VARIANCE APPLICATION SUMMARY

File Number	V-25-18
Property Address	721 CRESCENT WOODS DR GAHANNA, OH 43230
Parcel ID	025-014176
Zoning District	R-4 - Multi-Unit Residential
Project/Business Name	Casto Crescent Woods
Applicant	Don Haight
Description of Variance Request	Sign site C(1) Freeway sign client would like it 2' back of ROW to allow for planter box and sign at freeway. Retaining wall is also going to affect its location if has to be 15' back from ROW. Ground where it is proposed is much more level. Sign Site A we would like sign to be 6' from ROW. If we do the 15' setback the sign post would be right next to building and would not look proper in space is only 26', with sign being 8'6"wide. If anything we would like to center the sign in the space at least to look proportioned correctly at site.

PLANNING COMMISSION STAFF REPORT

Project Summary – Crescent Woods Signage

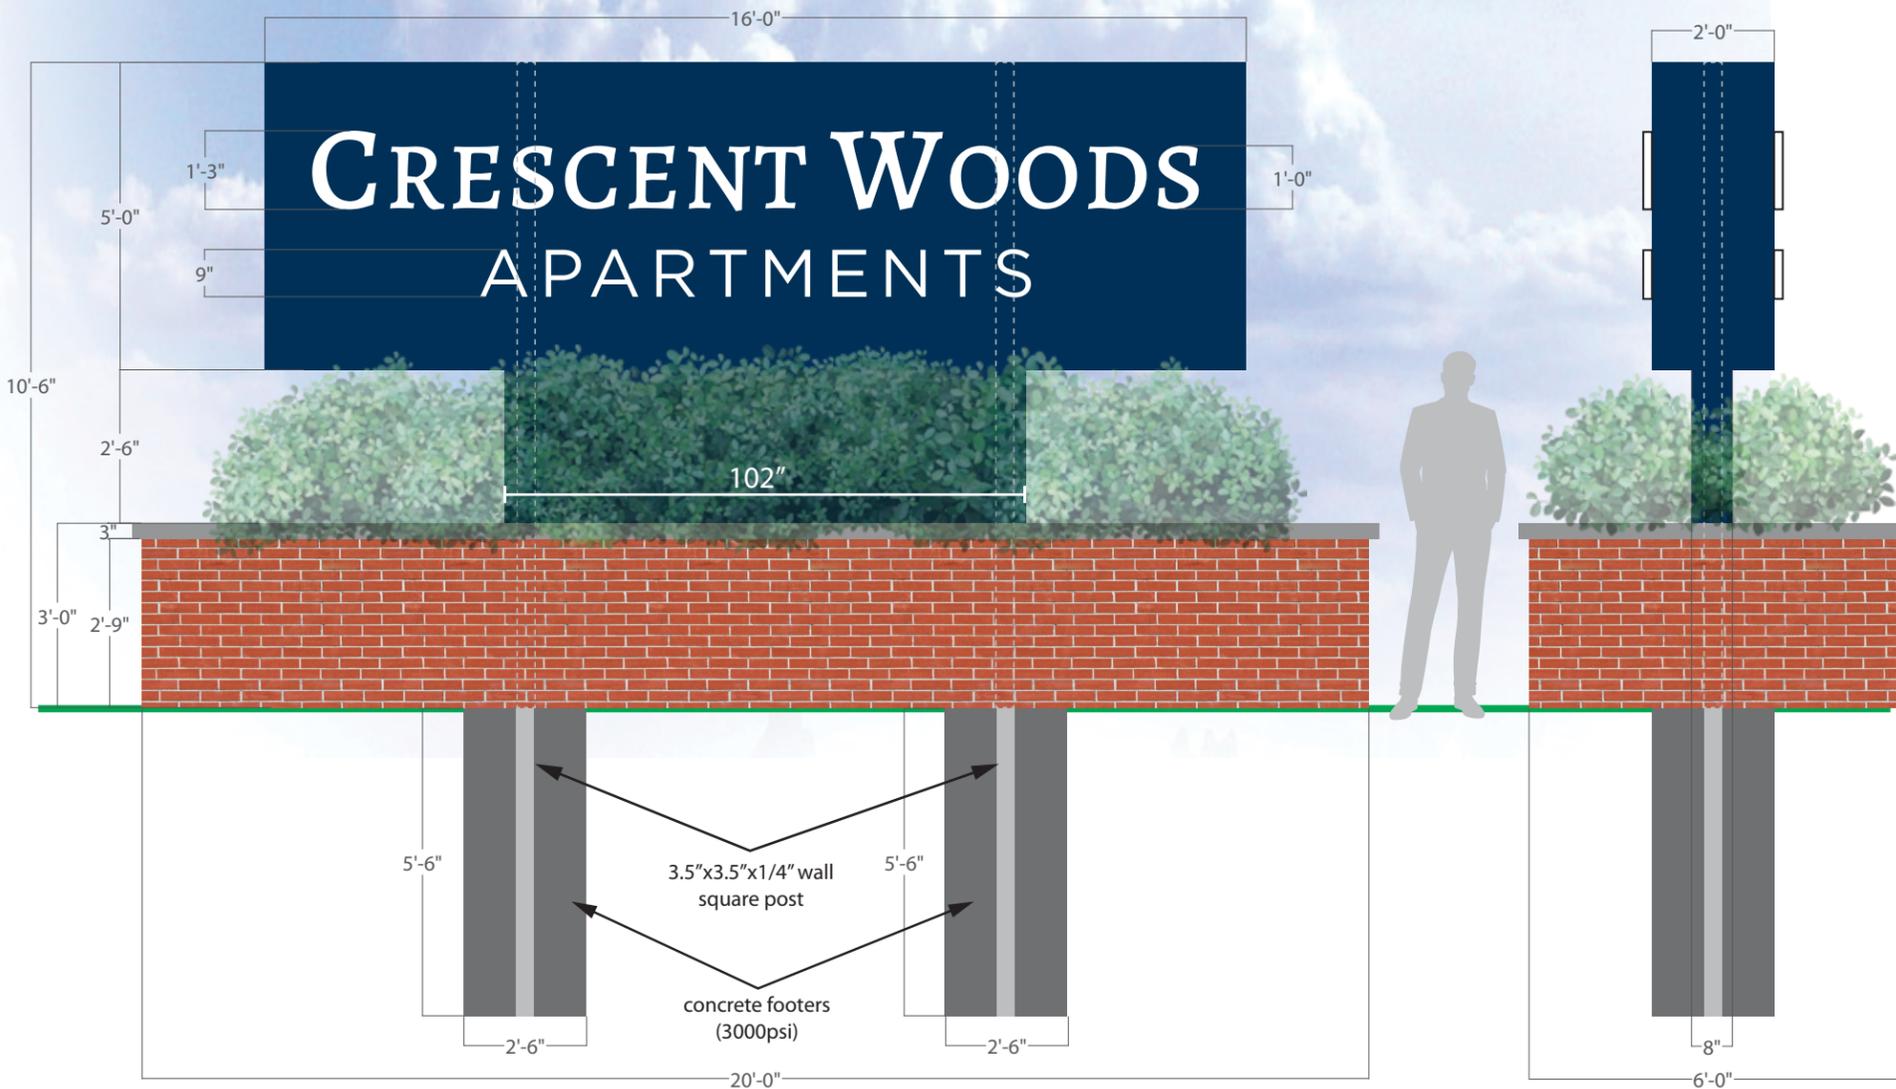
This letter is in response to a variance comment letter pertaining to the Casto Crescent Woods project and location of sign “C” at the northern most property line of project. We (CASTO) understand that said sign is located within an existing 27’ waterline easement. If for any reason this sign becomes in the way of future repairs or needed maintenance access to the existing utility (waterline), the property owner will take full responsibility for removing and/or repairing any structure or landscaping associated with sign and located within easement.

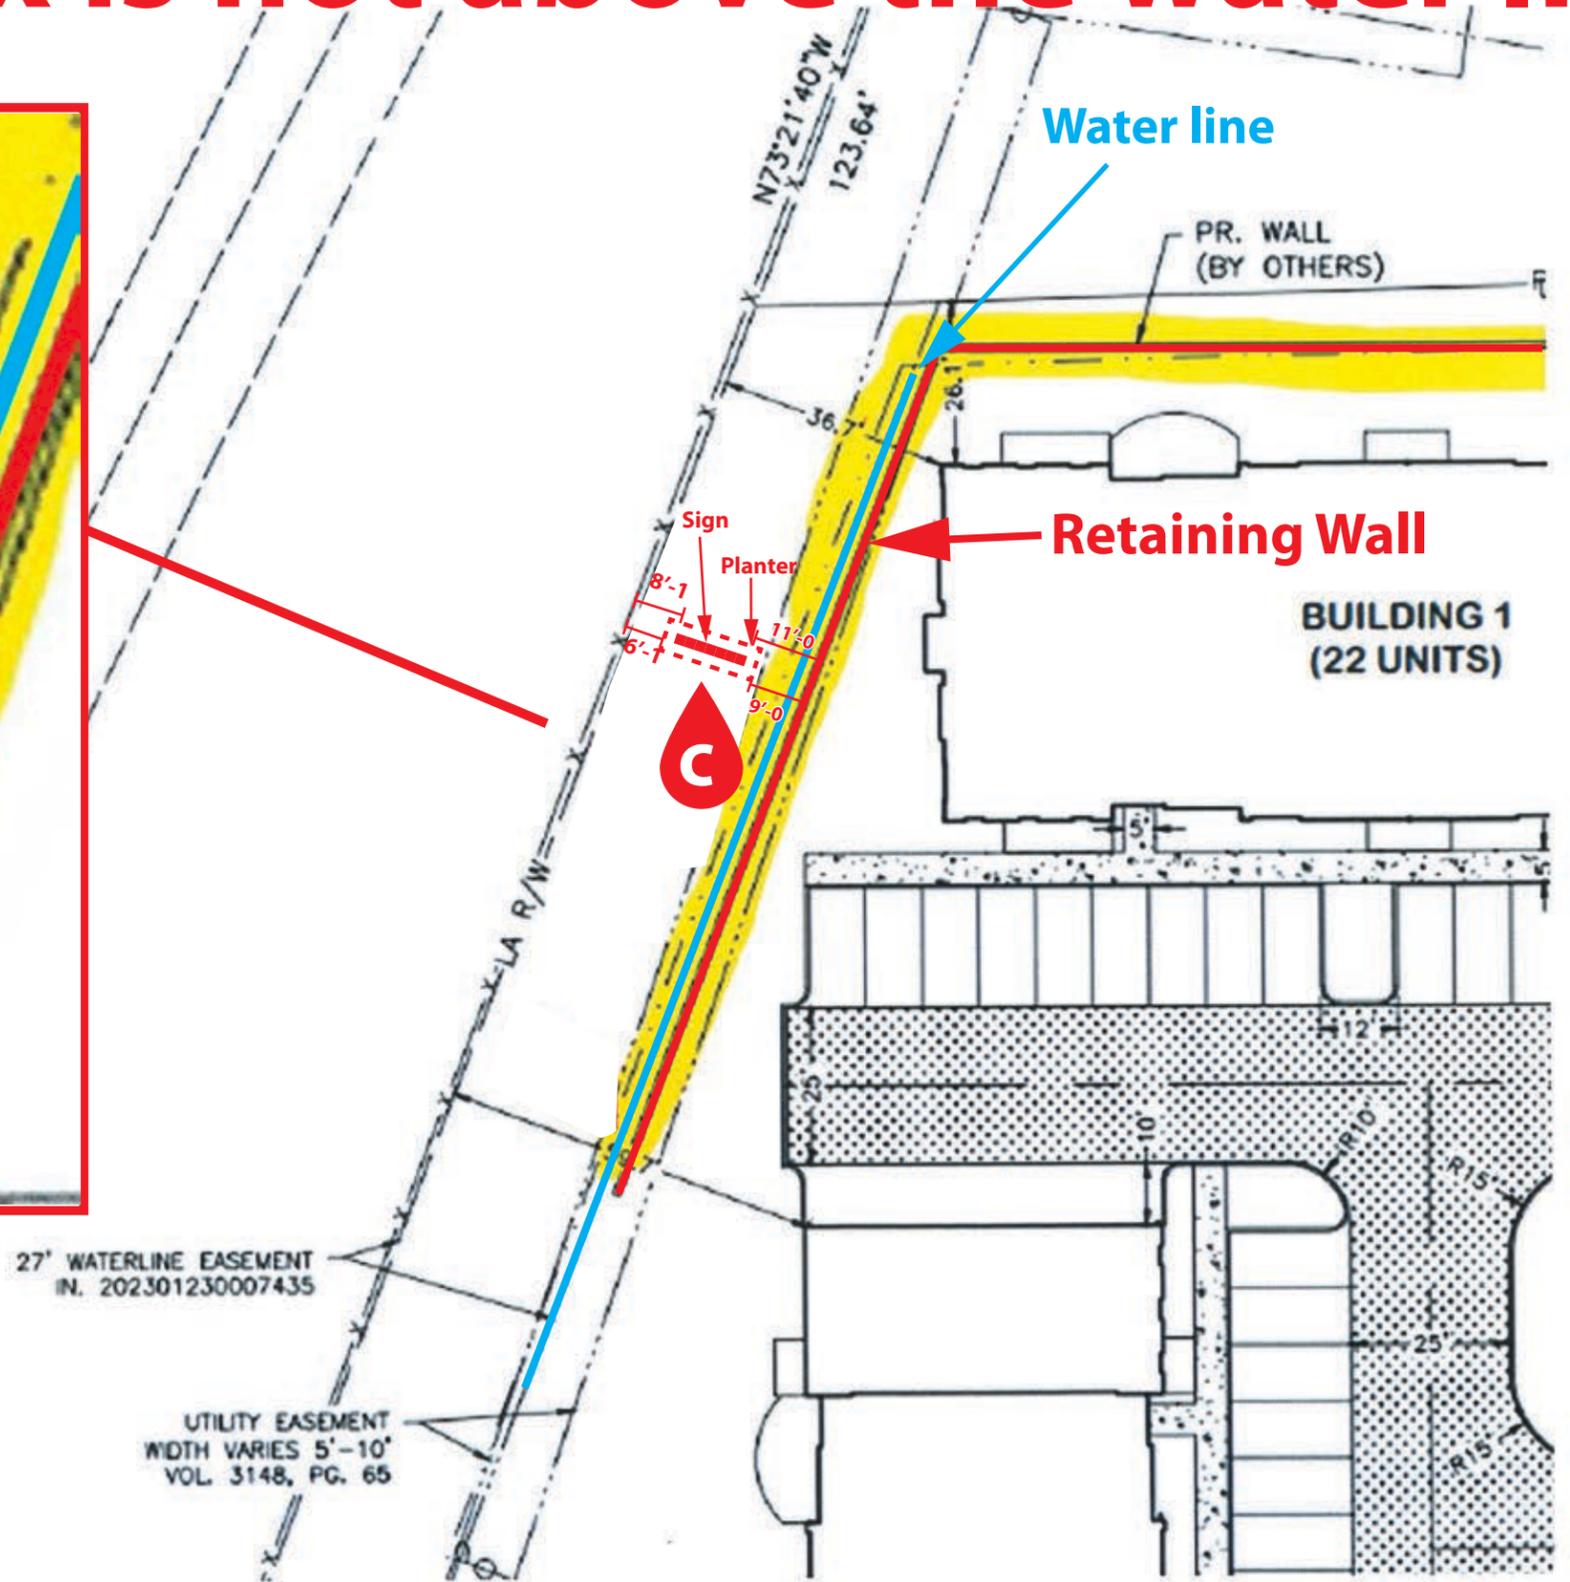
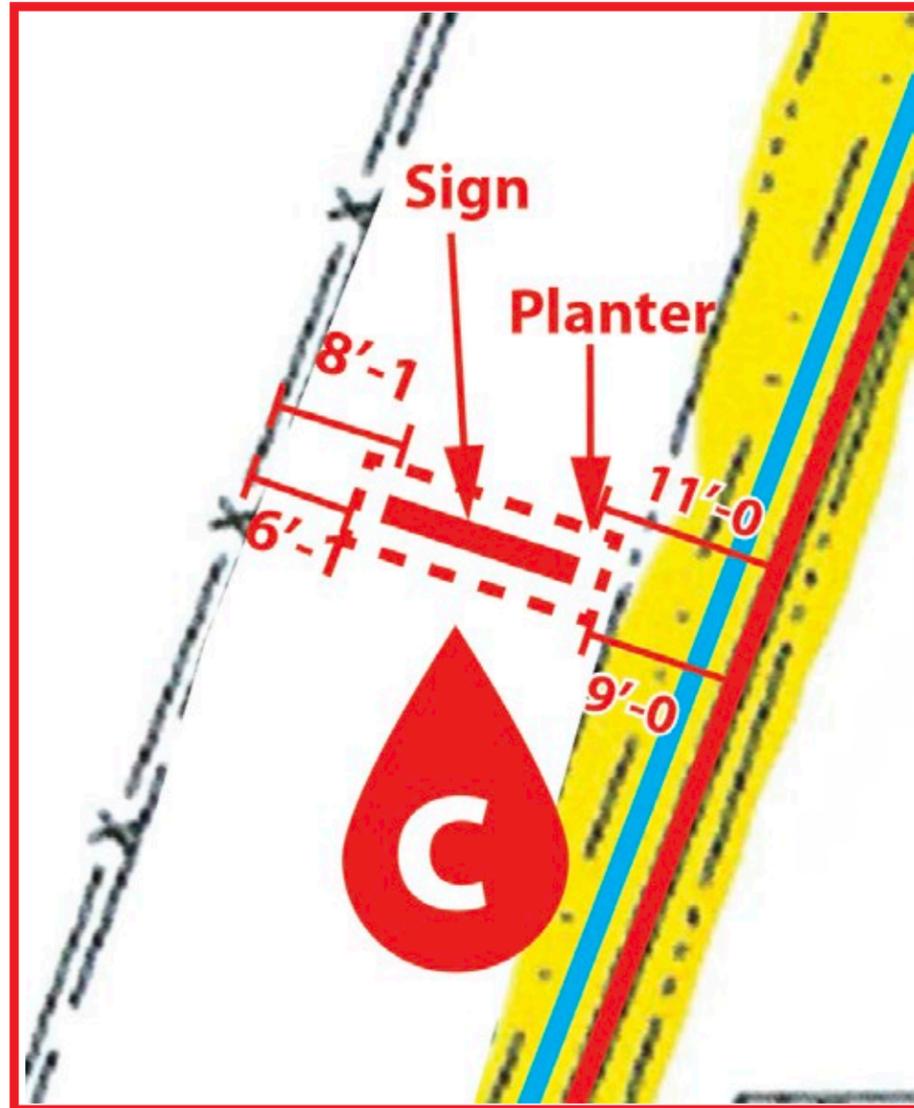
Sign and planter box is not above the water line

Water line

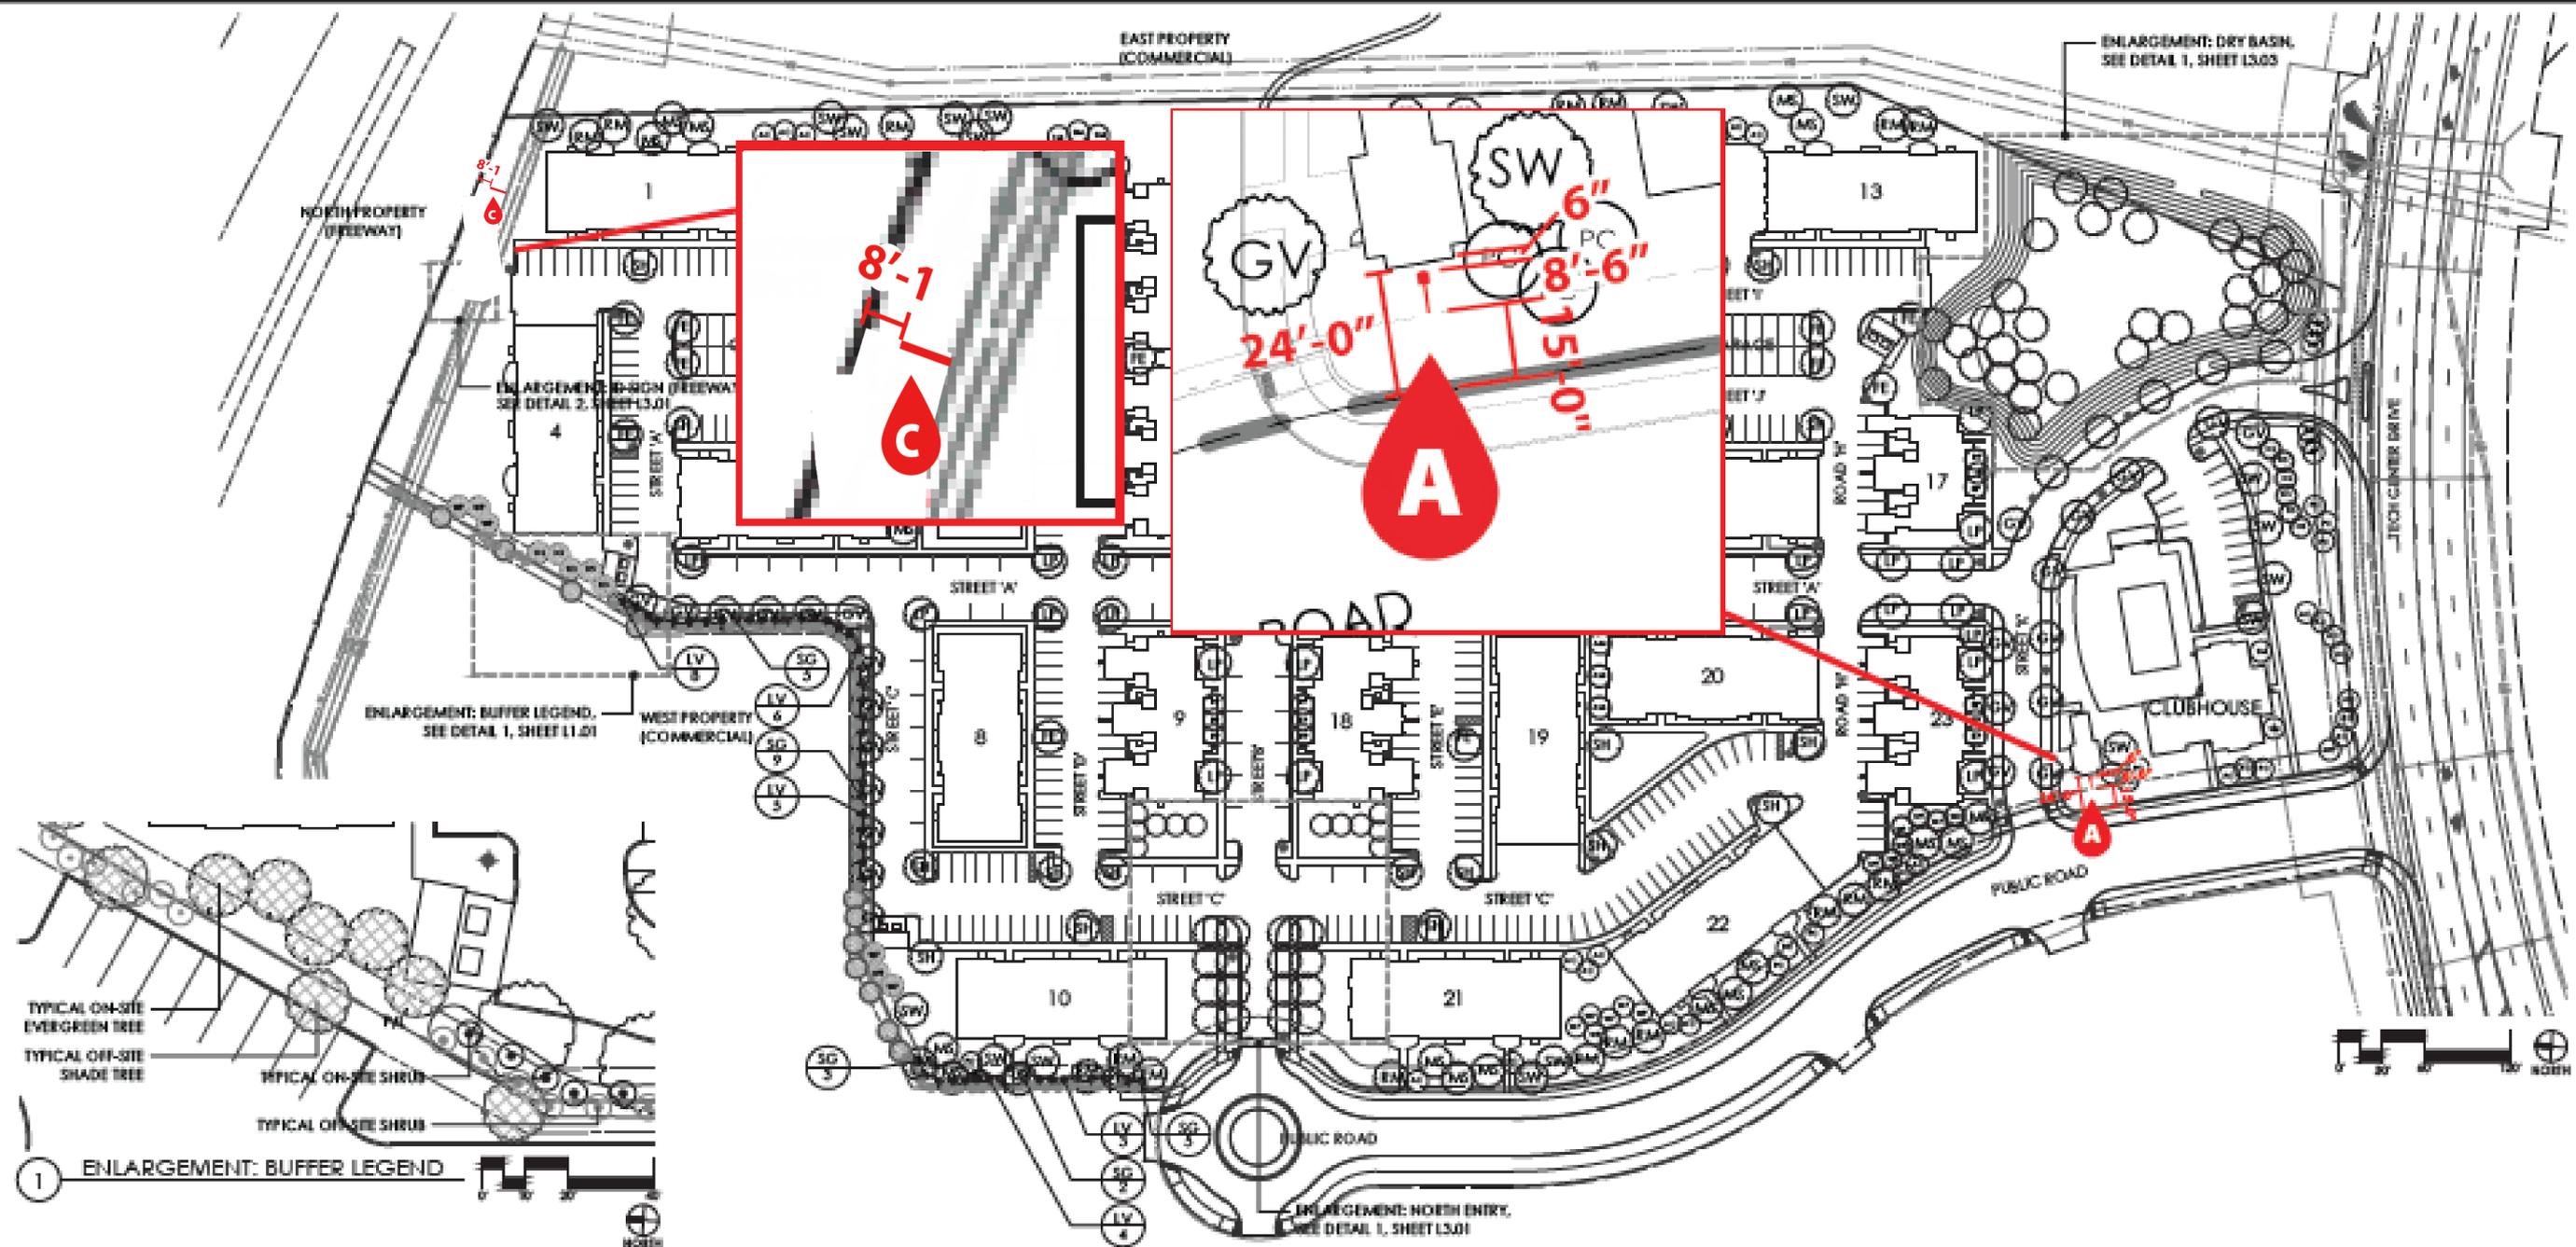
Sign and planter box is not above the water line
